The Great Grid Upgrade

Norwich to Tilbury

Targeted consultation

Location reference: [Essex 12](#)

Area of proposed change February 2025

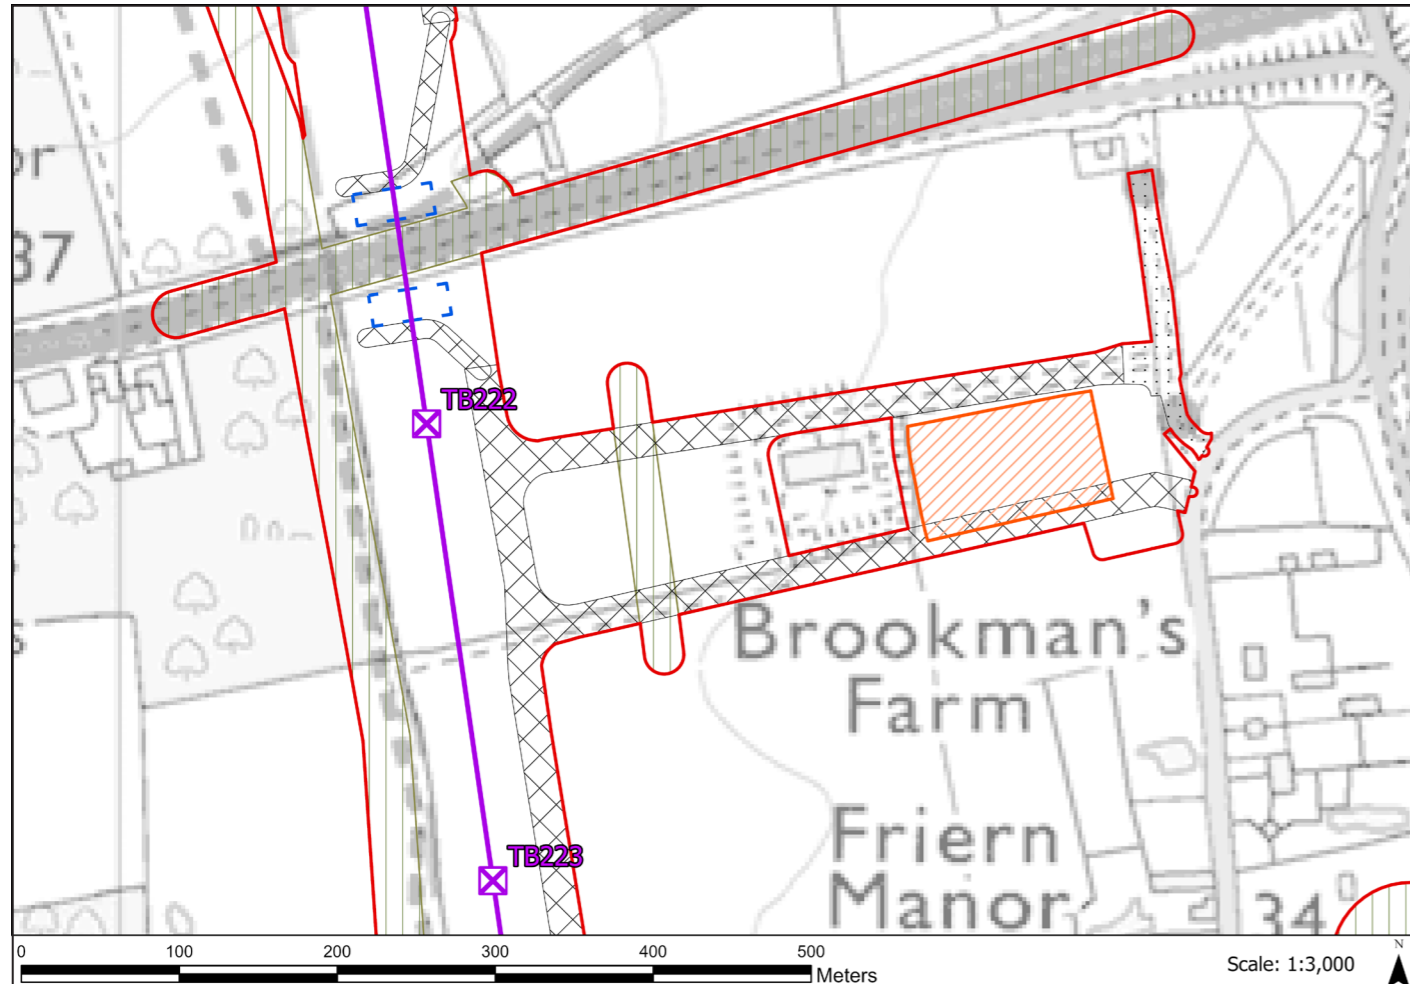
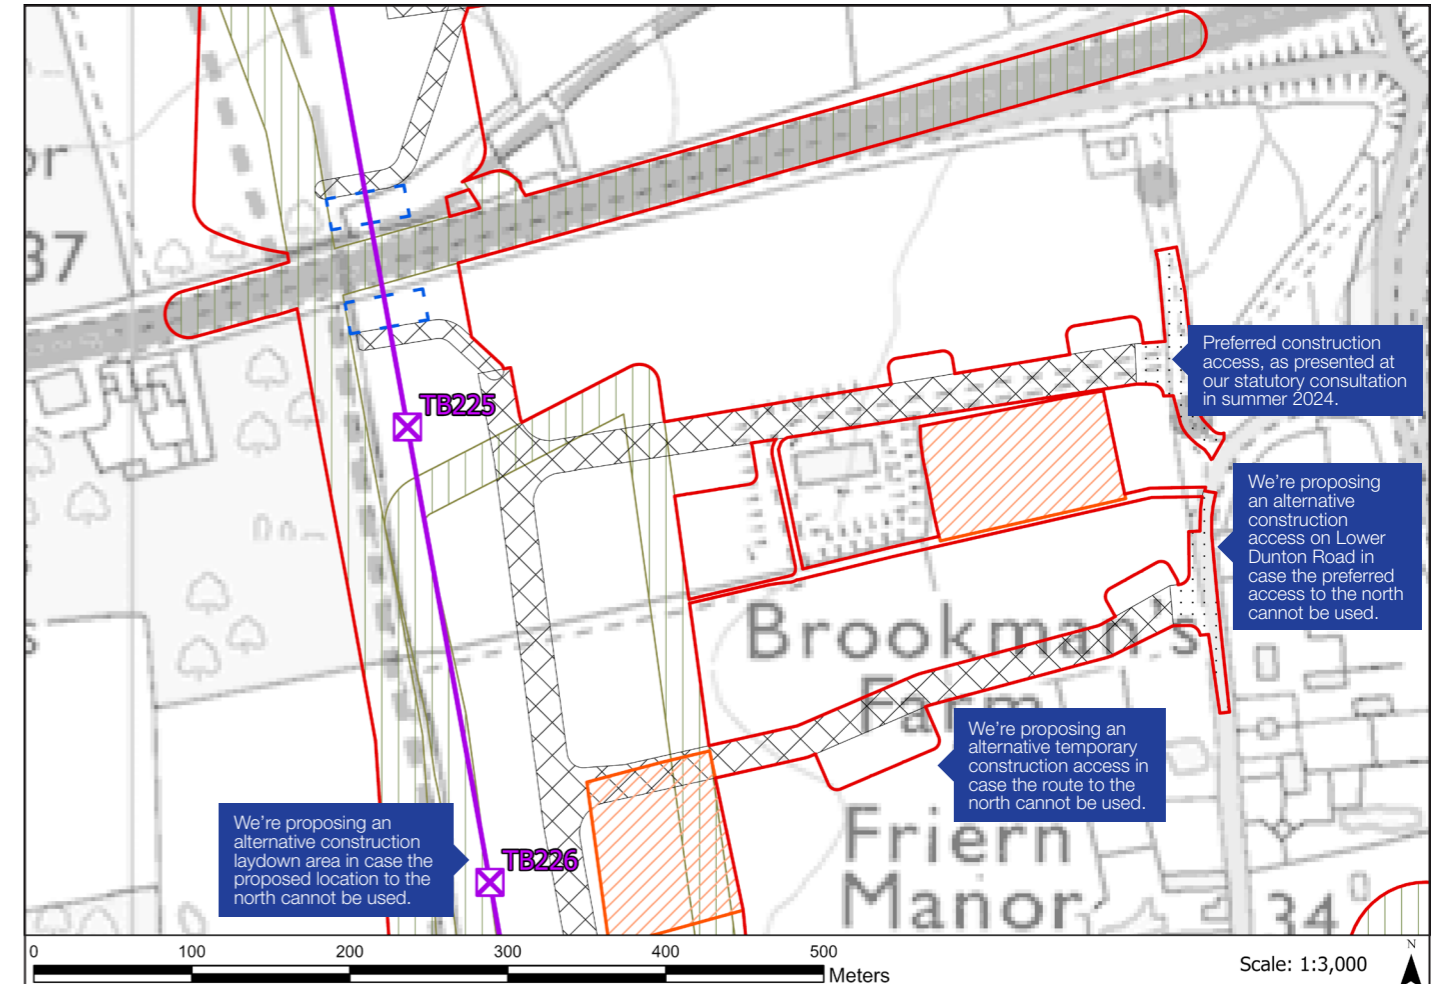
We are proposing to reposition the temporary construction access and laydown area location near Dunton Wayletts to the south of its location presented at statutory consultation in summer 2024. You can see both the design presented at our statutory consultation in summer 2024 and our currently proposed change on the maps overleaf. The proposed change would affect access to pylons TB225 and TB226 (previously presented at statutory consultation in summer 2024 as TB222 and TB223).

This change is being proposed following feedback which asked us to consider that future built development could be in the construction stage at the same time as the project and could therefore conflict with the proposed temporary access and compound arrangements presented at our statutory consultation in summer 2024.

The proposed change involves relocating the construction access road to TB226 (previously TB223), annotated on the map overleaf, and a new construction laydown area for this pylon. The proposed laydown area would be temporary, and the land would be returned to its original use after construction.

As there is some uncertainty over the timing of the built development, we propose to include both access arrangements. Our preferred access route remains the northern access at TB225 presented at the 2024 statutory consultation. This proposed access arrangement would be used in the event that the land used for the northern access at TB225 is being developed and cannot be used.
